**Stantec Consulting Services Inc.**  
12080 Corporate Parkway, Suite 200  
Mequon WI 53092-2661

December 2, 2022  
File: 193707141

**Reference: Response to Request for Additional Information #2; Materials Management Plan and Ch. NR 718 Exemption Request for C. Reiss Coal Dock Property, Superior, Wisconsin, BRRTS Case No. 02-16-589248**

DATE OF ISSUANCE  
 NOVEMBER 18, 2022

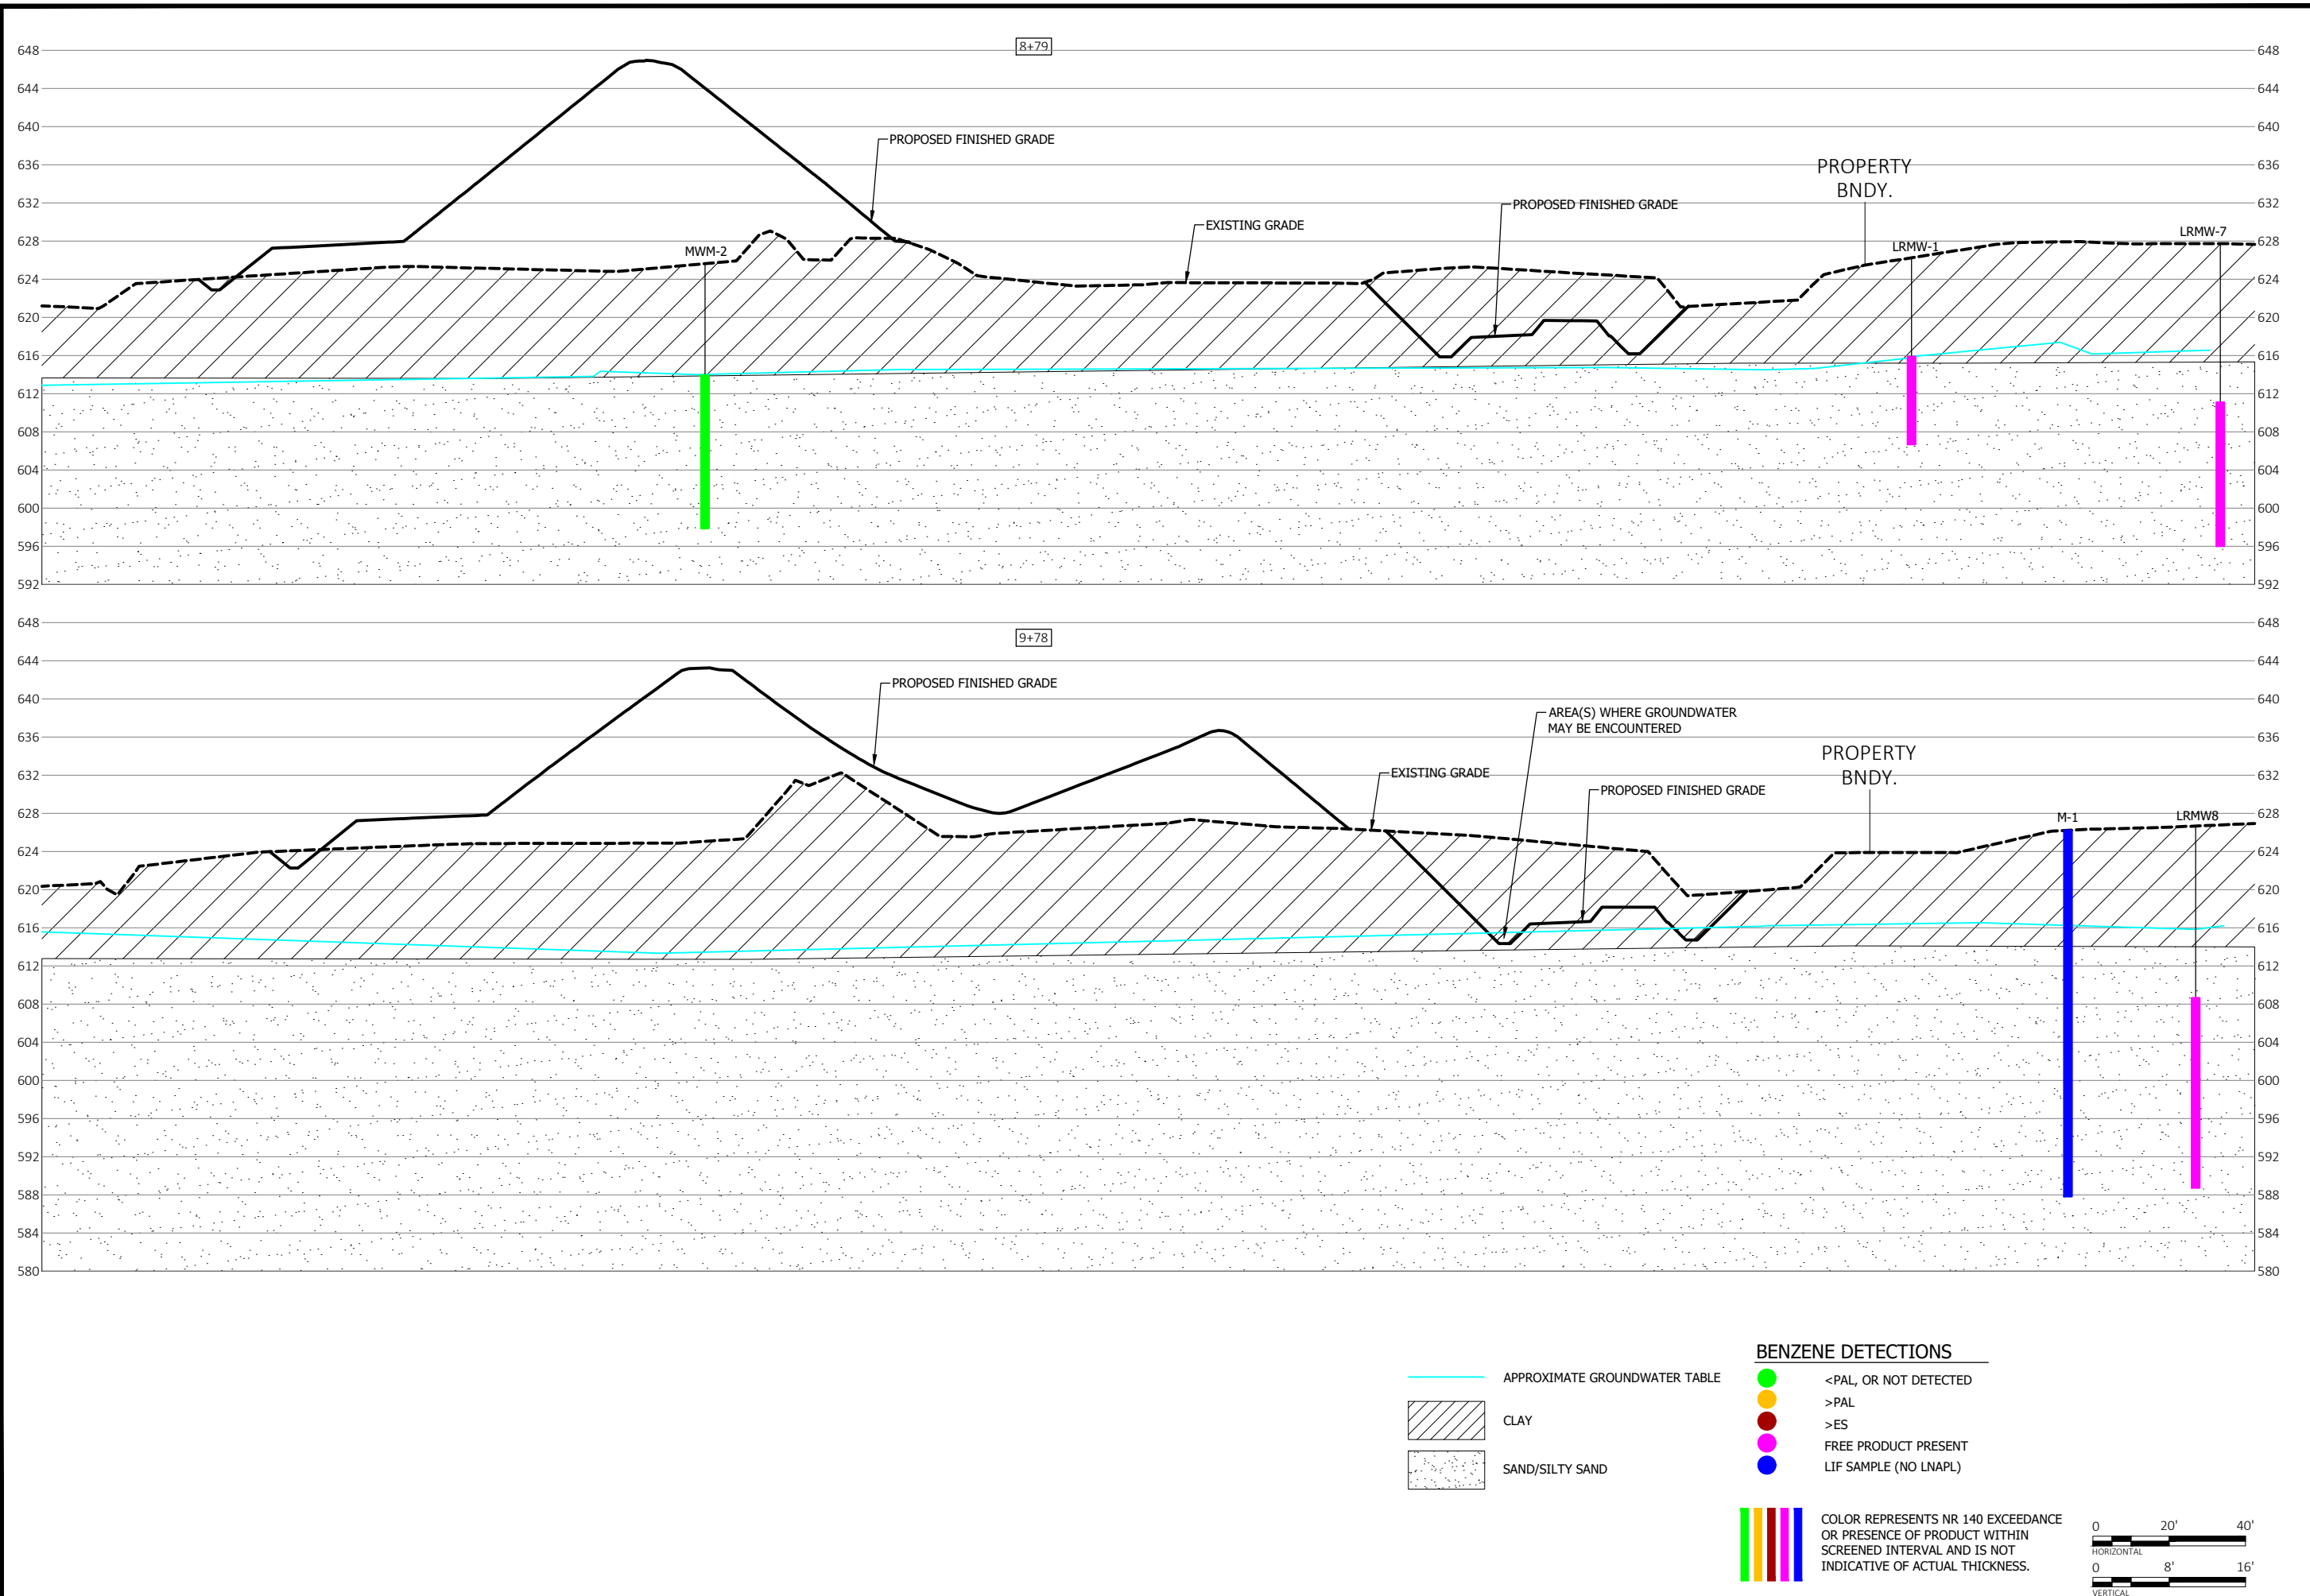
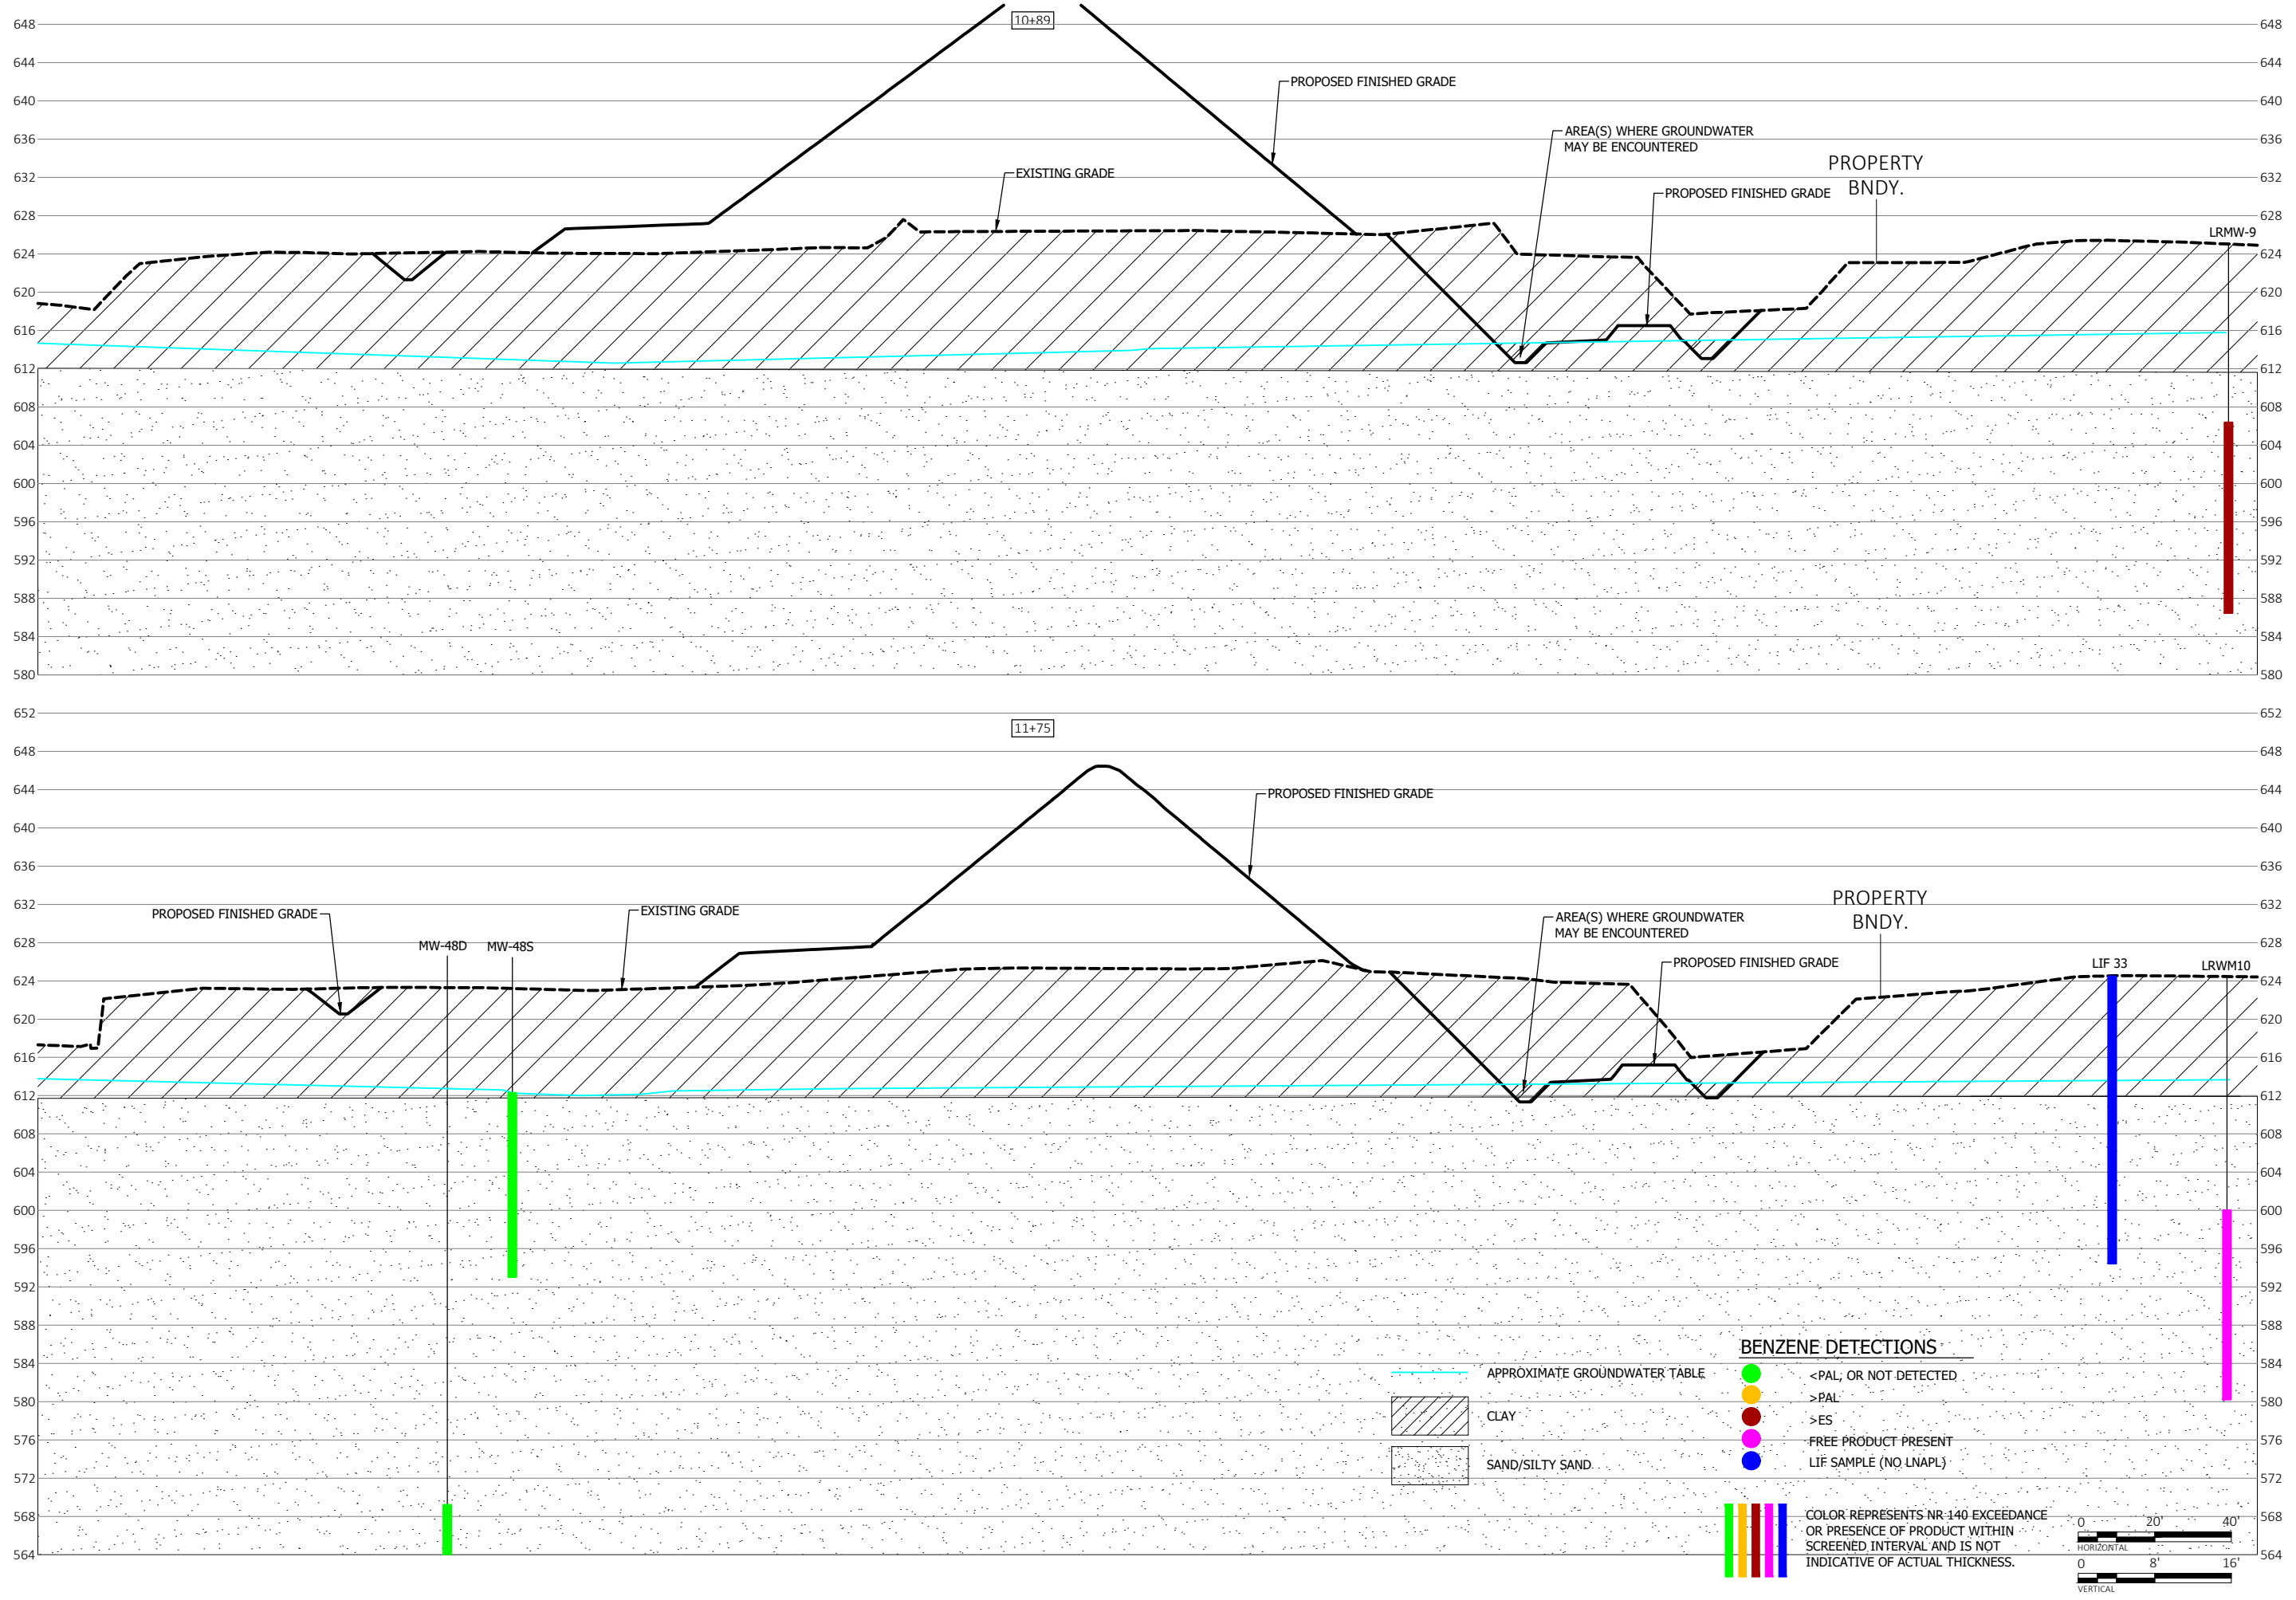
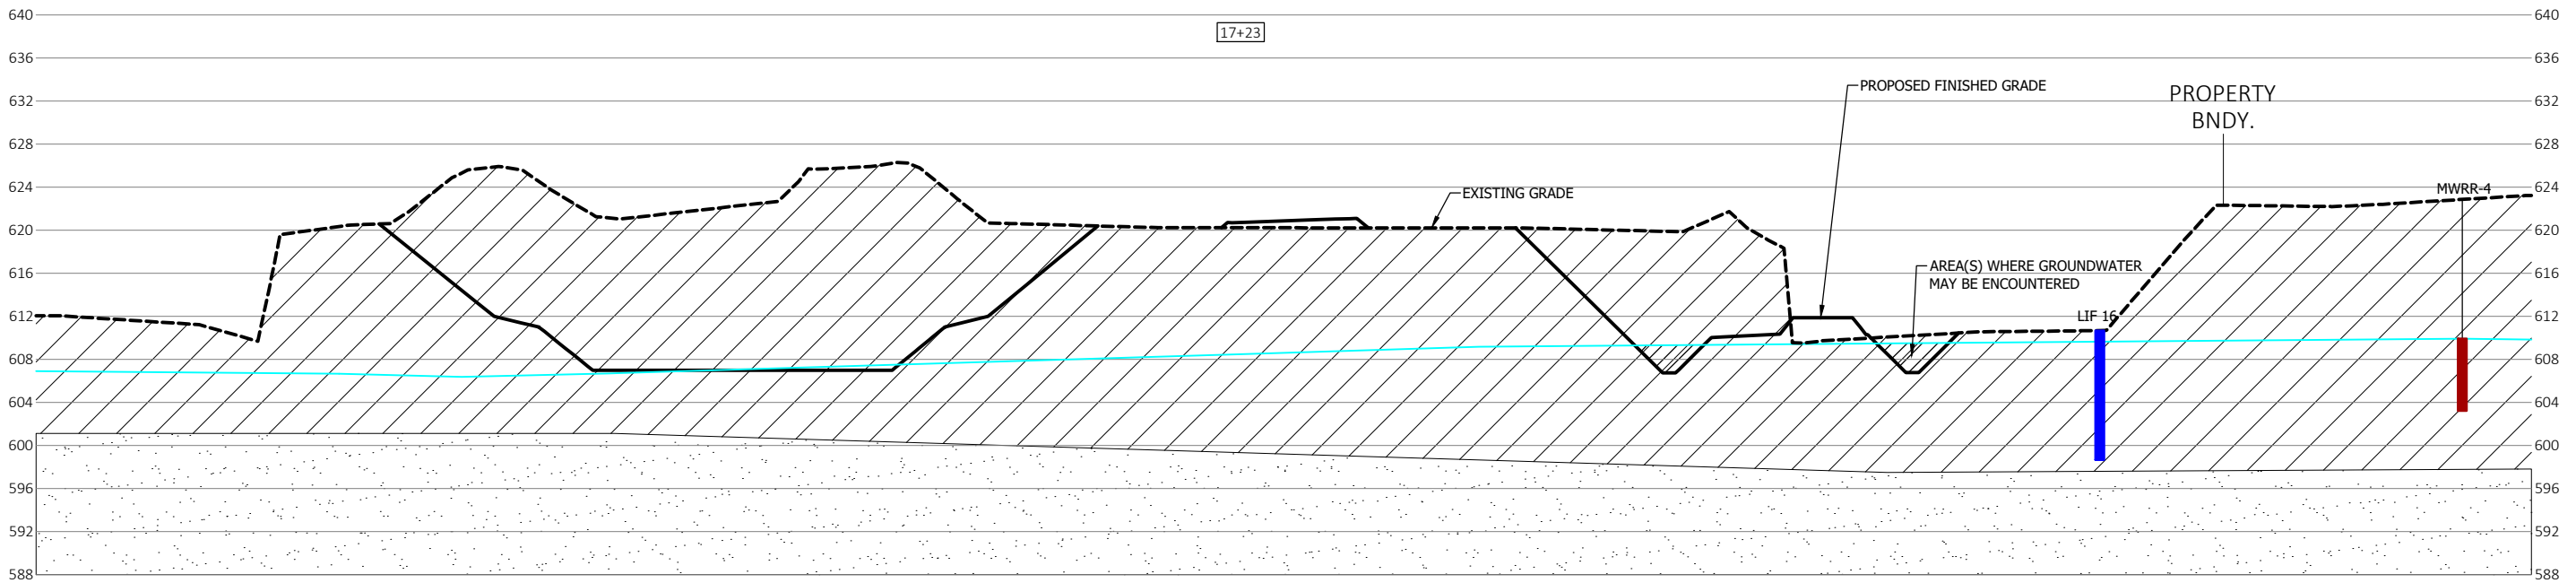
**2. The RR grade and stormwater pond call for excavating site soils, extending into the confining clay layer, and potentially breaching the clay layer. This, combined with the placement of large volumes of soil and sediment adjacent to these excavated areas, could impact the hydrogeologic conditions at the site. There needs to be an evaluation of both the geotechnical and hydrogeological aspects of the proposed excavation and placement of material. To what extent will the proposed activities impact groundwater conditions, including the migration of contaminated groundwater and LNAPL? Do you anticipate the potential migration of contaminated groundwater and LNAPL to the surface in excavated areas? In what other ways will site hydrogeological conditions be impacted by the proposed placement and excavation of material?**

**3. Contaminated groundwater and LNAPL on the adjacent property to the east are not shown in figures 7 & 8.**

**Clay unit.** The cross sections provided on **Figure 8** have been updated to illustrate the approximate depth/thickness of the clay unit present across the Property and depth of the underlying sand/silty sand based on available lithologic information collected by Stantec and others (AET, Antea Group

[Antea] to date. As illustrated on **Figure 8**, the maximum depth of cut is above the clay/sand interface for the majority of proposed Property redevelopment. The only areas where the proposed excavations will breach the clay unit and extend approximately 1 to 1.5 feet into the underlying sand/silty sand are at Stations 11+75 and 15+10. This area is far north of the LNAPL finger plume, and west of the smaller LNAPL plumes on the east-adjointing Property which (as discussed above) are limited in nature and not anticipated to impact proposed property excavations. Therefore, no mobilization of LNAPL or contaminated groundwater is anticipated as part of proposed Property excavations.

**Response:** **Figures 7 and 8** have now been updated to include available groundwater and LNAPL information on the parcels adjacent to the Property (including the east-adjointing property) and are included as attachments to this submittal.

As discussed in Response #2, LIF data available for the Property in areas near the smaller LNAPL plumes present along the east-adjointing property (north of the “finger plume”) have also been added to **Figures 7 and 8** to illustrate that LNAPL impacts from these smaller plumes are limited in nature and are not anticipated to impact Property construction.
